October 13, 2015

This Addendum to the Invitation for Bids (IFB) serves to notify all interested bidders of clarifications and/or changes to IFB No. B15003 General Contractor for Firebaugh Multifamily Apartments, and becomes part of this IFB. Contractors are required to acknowledge receipt of this addendum in their proposal. If not acknowledged, Contractor's proposal may be considered "non-responsive."

TUSCAN COLUMNS 1

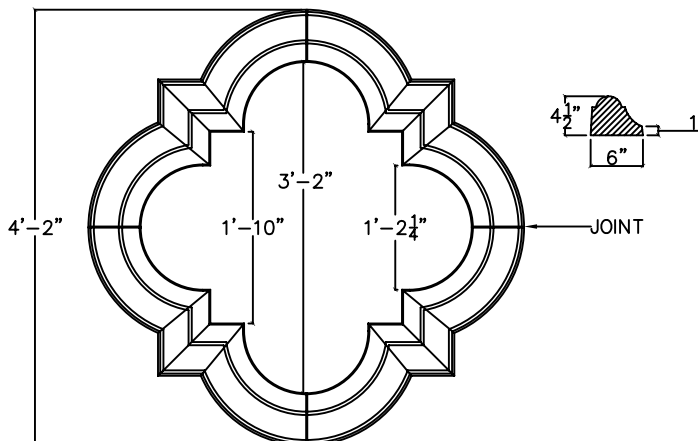
- **Q1: We see the precast columns and emblems in the plans, and there is a note on Page 3.2 to see Page 6.X. Please advise where those details are located.**

- *A1: The columns should be 2-piece GFRC tapered columns (similar to Tuscan Entasis columns by Ventura Stone) installed per manufacturer recommendations and the attached specification (Attachment 1.0 to Addendum #8) Section 03490 (see attached catalog page from Ventura Stone, Attachment 1.1 to Addendum #8). The quatrefoils detailed at 17 & 18 on Sheet A6.10 shall also be GFRC pre-fabricated products to match Ventura Stone GFRC Q50 or similar. See attached catalog page from Ventura Stone (Attachment 1.2 to Addendum #8).*
